AIO Card ASIC Digital Noise Modification

FIGURE 4. ASIC Modifications

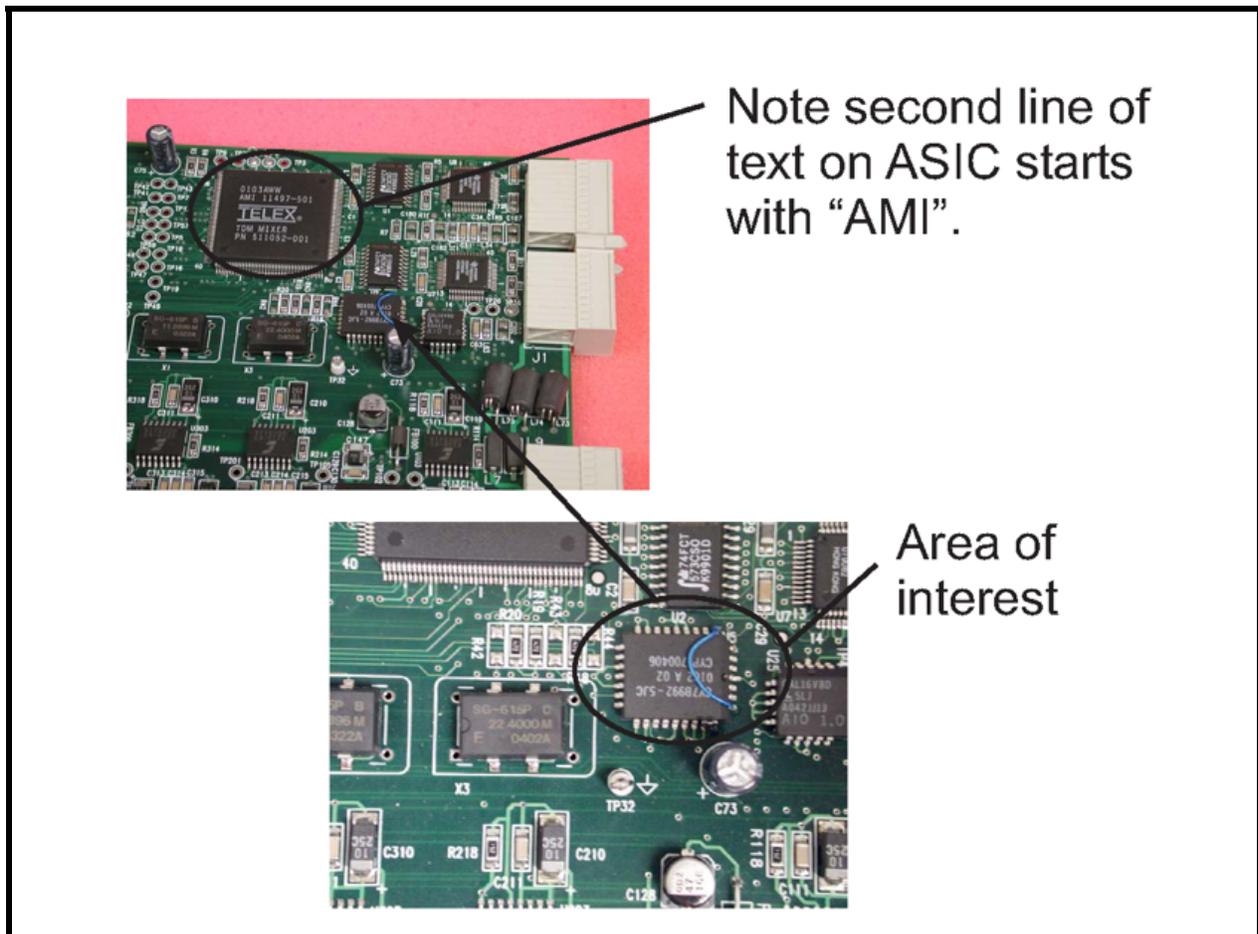
An audible sizzling or frying noise can be heard in Port-to-Port audio through the ADAM Matrix. This is more prevalent in end cards.

A timing problem exists in Telex TDM ASICs fabricated by AMI.

Changing the AIO card timing scheme to accommodate the increased delay needed by ASICs fabricated by AMI.

1. Using kynar or other suitable jumper wire, **run a jumper from U5 pin 5 to U5 pin 30**, as shown in the photo below.
2. Create a **solder bridge between pins 28 and 29 on U5**.
